Preliminary Consultation
MONTGOMERY COUNTY HISTORIC PRESERVATION COMMISSION
STAFF REPORT

Address:	11801 Bethesda Church Rd., Damascus	Meeting Date:	8/12/2020
Resource:	Individually Listed Master Plan Site Mendelsohn Terrace	Report Date:	8/5/2020
Applicant:	Stewart E. Walker, III Frank Baylor, Architect	Public Notice:	7/29/2020
Review:	Preliminary Consultation	Staff:	Dan Bruechert
Proposal:	Building addition and accessory structure demolition

ELEVATIONS

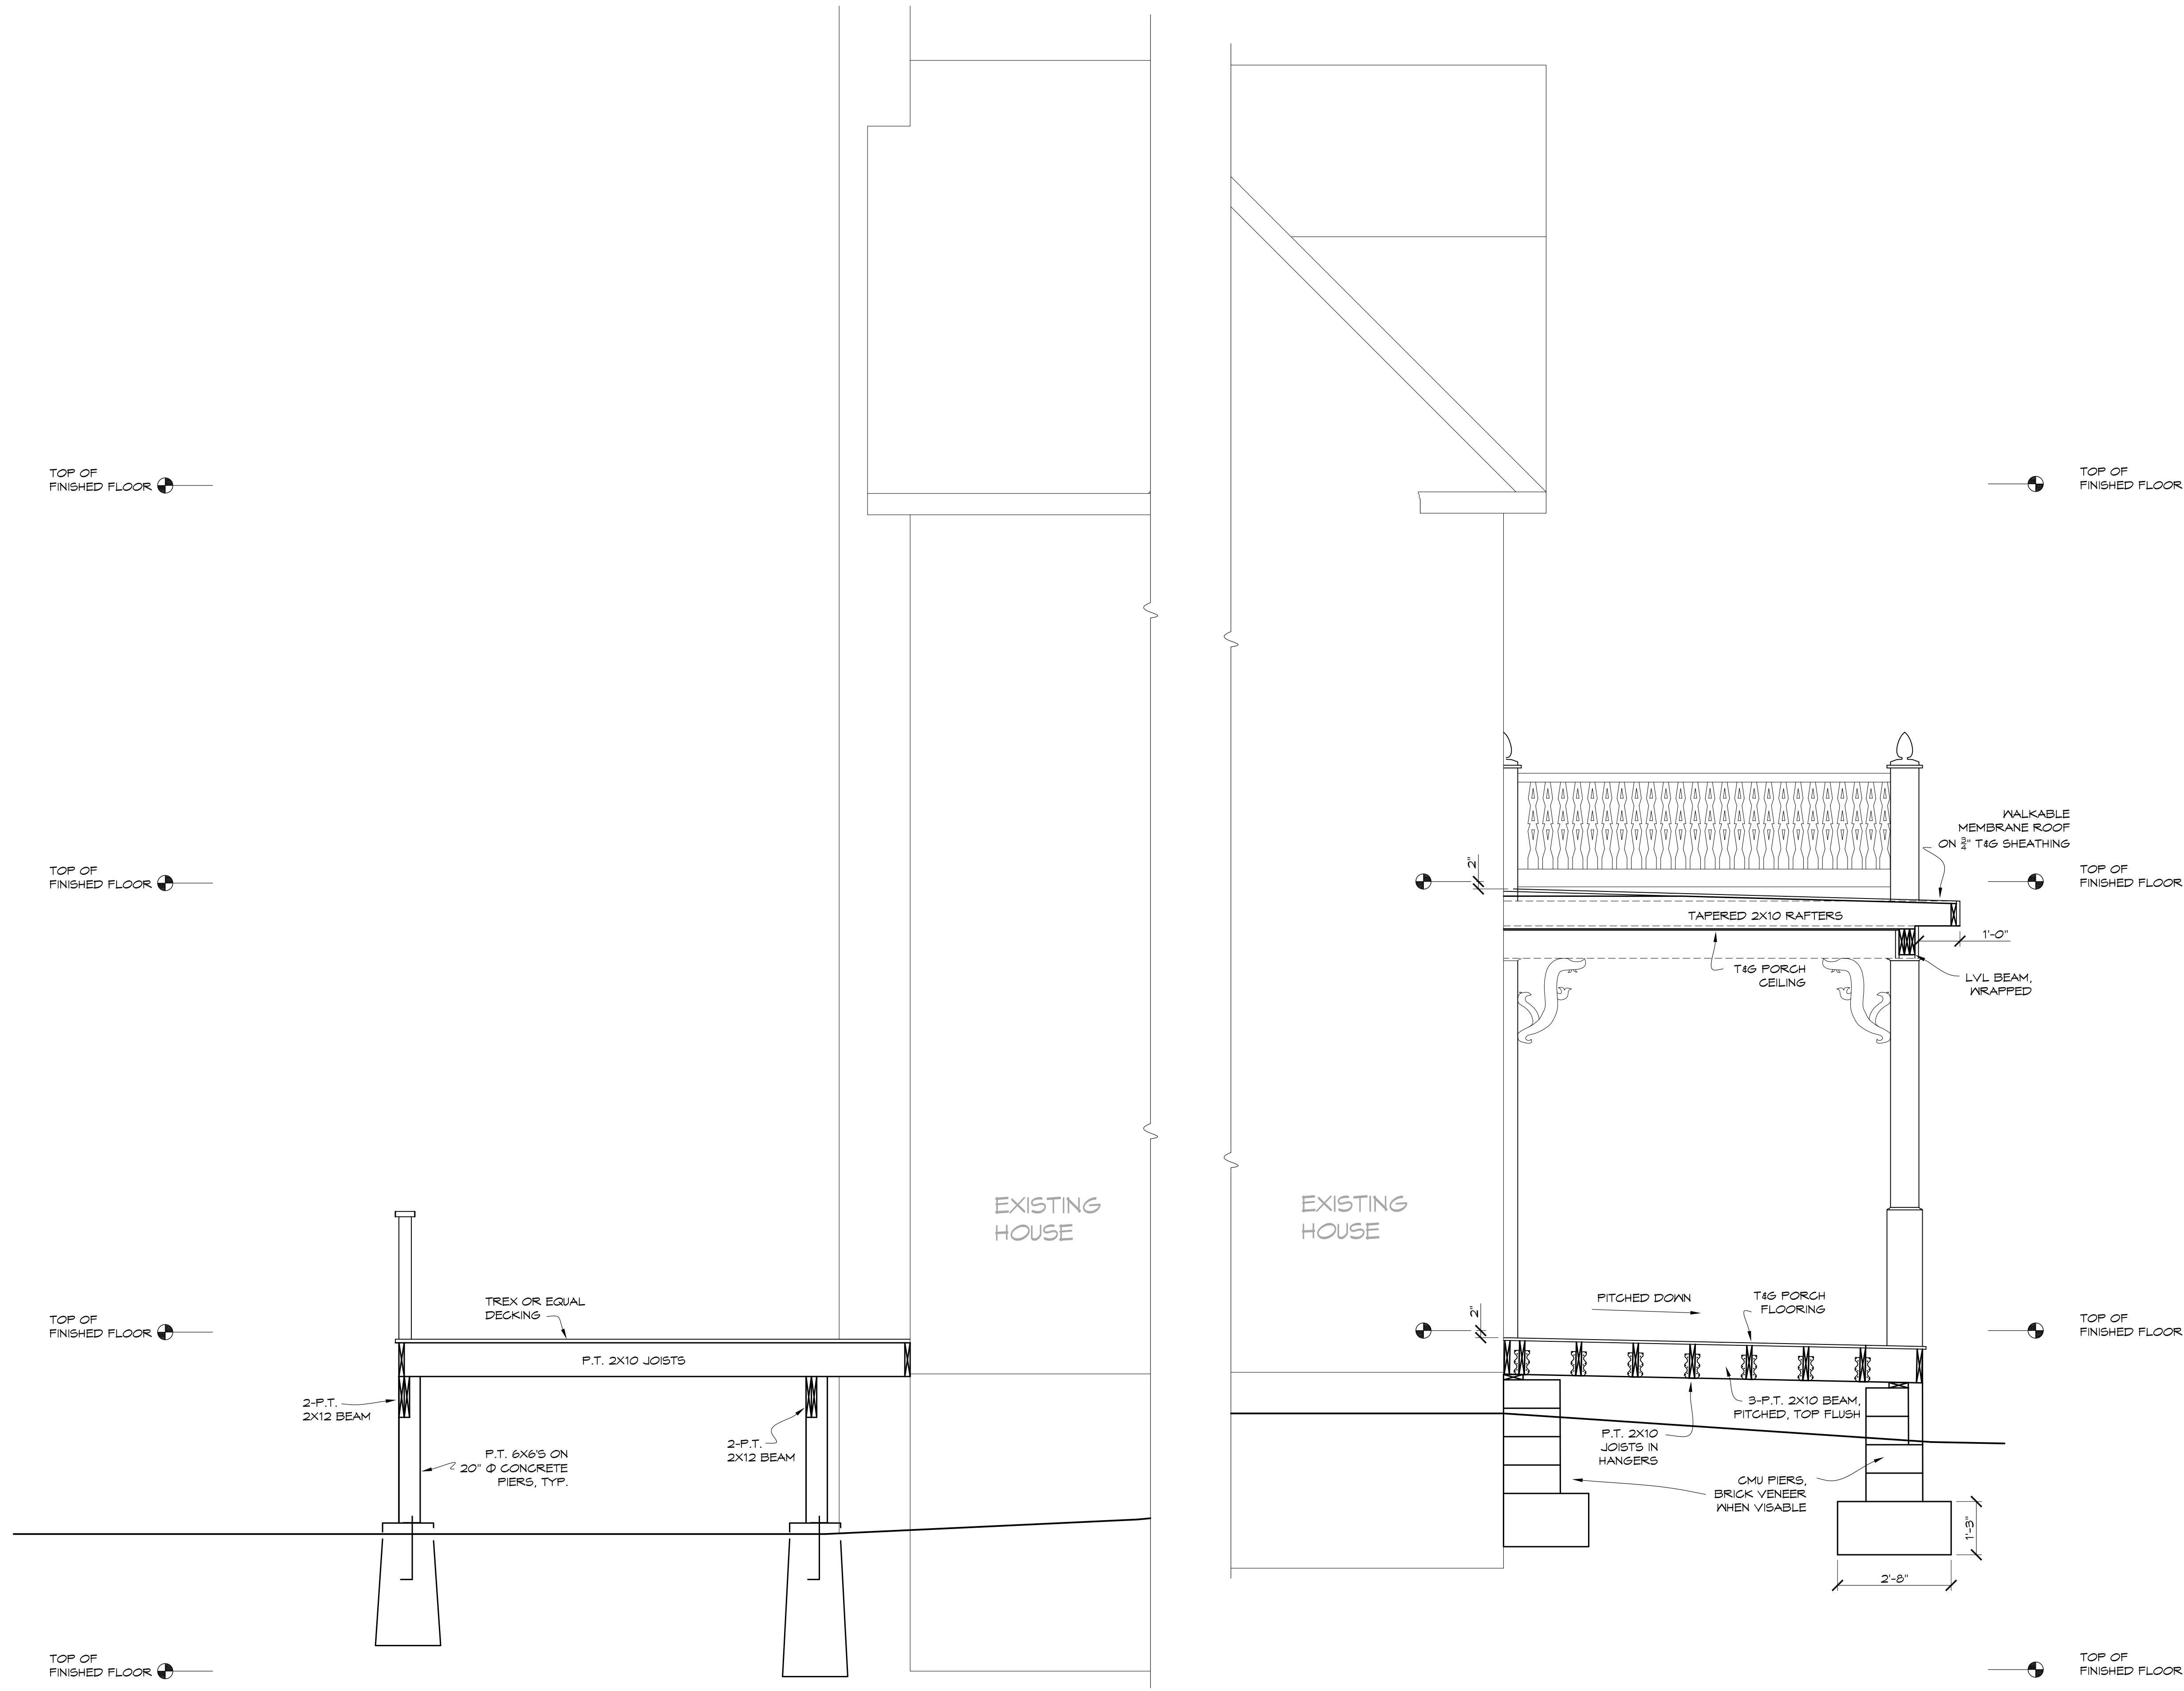
Staff finds that it may be appropriate to construct an addition to the rear of the house, as the photos show there was construction historically in this location. However, Staff finds that the proposed addition is out of scale with the historic house. Standard 9 requires related new construction to be compatible with the scale and massing of the historic; and the proposed addition is larger on both accounts. The footprint of the proposed addition is approximately 1000 ft². With the proposed two-story porch, the addition adds 1240 ft² to the total footprint. This appears to be an increase in the size of the building by about 75%.

The proposed roof ridge rises above all of the historic roof ridges. Most additions to historic architecture require the new construction to be lower than the historic construction so that the new is subservient to the historic. Staff notes also, while there was no front elevation included in the application, the roof of the proposed addition over the two-story porch will project beyond all of the existing construction and significantly alter the mass of the building. Staff finds the proposed construction is too large and needs to be revised before returning for a second preliminary consultation or HAWP.

In further evaluating the plans, it appears that the attic of the addition will not be an occupiable space. A reconfiguration of the proposed addition that utilized a different roof form, could substantially reduce the mass of the proposed construction. Staff further recommends eliminating the two-story porch to reduce the apparent mass of the addition.

Staff finds the utilization of one-over-one sash windows in the new addition to be appropriate. Using a different window pattern is a tool typically applied to help differentiate new construction from the old. However, Staff does not find the large expanses of glazing on the left elevation to be compatible with the architecture of the addition or the historic house and recommends a design revision based on feedback from the HPC.

The addition includes two new chimneys. The exterior of the chimney on the left elevation will be visible from its full height. The chimneys will be constructed out of CMU with a stone veneer. Staff finds that chimneys in the proposed location is not out of character with the house, but finds that the height and size of the proposed chimneys are too tall to be compatible with the historic house as they tower over all of the historic construction. Additionally, Staff finds that the stone is also not compatible with the historic construction. The existing chimneys are all brick. While differentiation between the historic construction and the new is desirable, compatibility also has to be considered under Standard 9. Introducing another material to the exterior of the house detracts from the character of the historic house, which was constructed with only wood, glass, and brick. Staff recommends the proposed chimneys be reduced in size (both width and height) and use a brick veneer instead of the proposed stone.

Staff requests the HPC to provide recommendations for improving the size, scale, and massing of the proposed construction to bring it into conformance with Chapter 24A of County Code and the Secretary of Interior's Standards for Rehabilitation.
